**THI QAR BEE FARM
THI QAR, IRAQ**

**SIGIR PA-09-188
APRIL 1, 2010**

SUBJECT: Report on the Thi Qar Bee Farm, Thi Qar, Iraq (SIGIR Report Number
PA-09-188)

Figure 1. Conceptual design of honey processing facility (Courtesy of GRS)

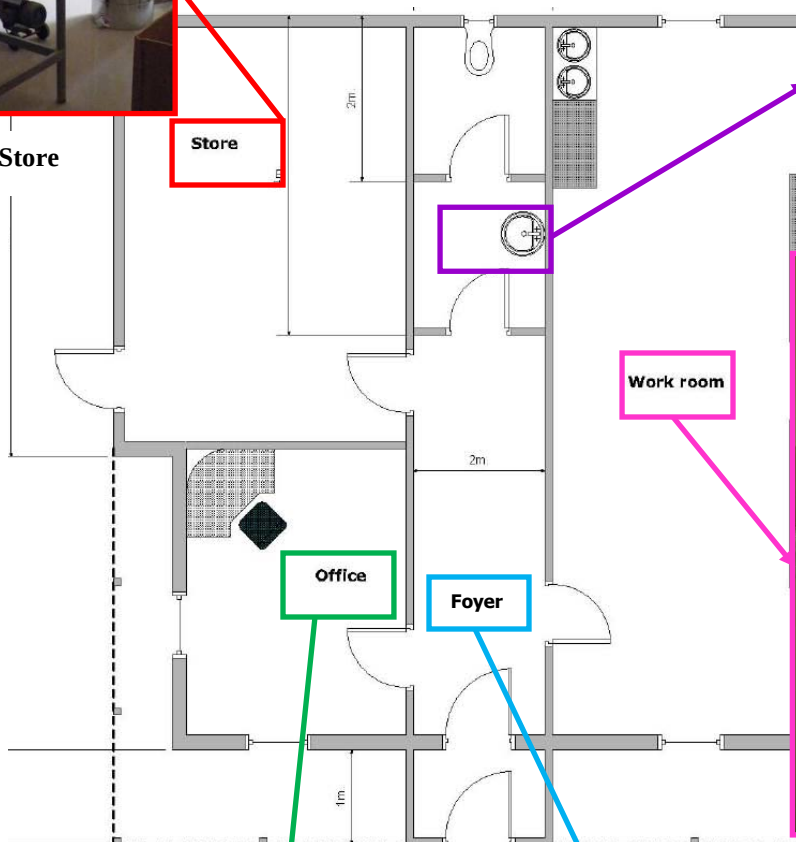
The building was constructed with three primary rooms and one restroom (Figure 1). The finish in all of the rooms was similar—plaster and painted finish for the walls, and ceramic tiles for the flooring. The finishes appeared well applied and in good condition.

When entering the building through the foyer, the office and store are located on the left, the restroom is straight ahead, and the work room is on the right. The store area was equipped for processing honey and was well-maintained (Site Photo 7). Several tables were available for workers to perform the various tasks required for processing, and equipment was located in this area.
